APPENDIX H: ACCESS REPORT

DA ACCESS REPORT

PROJECT NAME Raymond Terrace Bowling Club
2 Jacaranda Avenue, Raymond Terrace NSW
Phase 1: Bowling club, car parking and croquet lawn
Phase 2: Bowling greens
Phase 3: Hotel and car parking
PROJECT NUMBER CA230071-DA
CLIENT Raymond Terrace Bowling Club

REVISION	ISSUE DATE	DETAILS
Draft 1	6 November 2023	Issued for updates
Draft 2	16 November 2023	Issued for information
Final	17 November 2023	Issued for DA

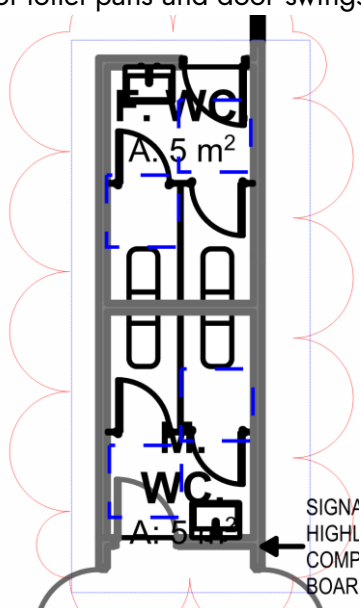
- a) Male and female ambulant toilets for the ground floor board room/function room lack 900 x 900mm circulation spaces both between outer doors and the cubicle walls/doors and within ambulant toilets clear of toilet pans and door swings.

Amend for CC

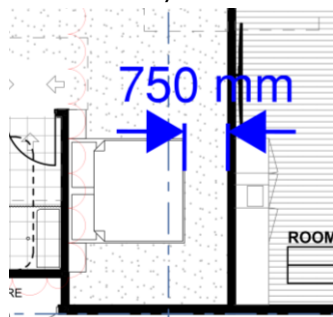
| 9.3 | While the BCA does not address room dimensions for the main bedrooms in accessible sole-occupancy units, it is recommended that at least 1540 is provided on one side (or foot) of the bed and that 1000mm is available on the remaining sides (or at the foot) to enable wheelchair circulation and transfers on/off the bed. | | |

The spacing in the main bedroom of Room 47 will prevent access to the foot and far side of the bed for most wheelchair users and may restrict their ability to transfer onto/off the bed.

Consider best practice
